Design & Construction Field Bulletin

Date	May 2, 2016 (Issuance #001)
Field Bulletin No.	FB-003 2016 (2 pages)
Category	Finishes, Fixtures and Furnishings
Subject	Pendant lights over front counter
Prototype Set Referenced	PLK 15 Series Drawings
Prototype Drawings Referenced	Pre-Sale Board Elevation (@ Front Counter 4/A12a)
D&C Contact	design@popeyes.com

4 PRE-SALE BOARD ELEVATION (@FRONT COUNTER)
 A12a 3/4"=1'-0"

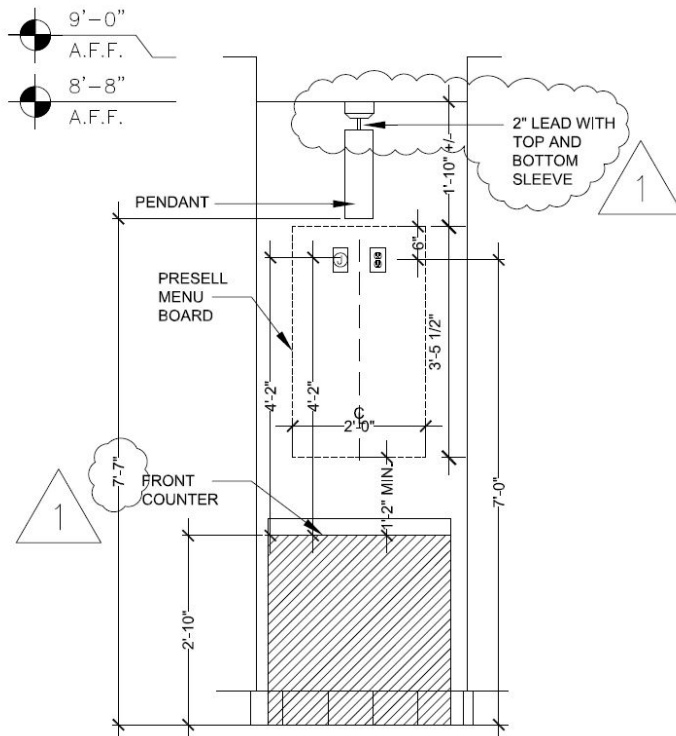
The pendant lights are being installed at 7'-0" AFF to the bottom of the pendant shade which blocks the view of pre-sale board from the guests.

Refer to the following drawing to correct this issue.

Correct Installation method

The current lead must be trimmed and the sleeve of the base and the lamp must touch as shown. The sleeves on the base and the pendant cannot be easily removed without compromising the assembly causing breakage.
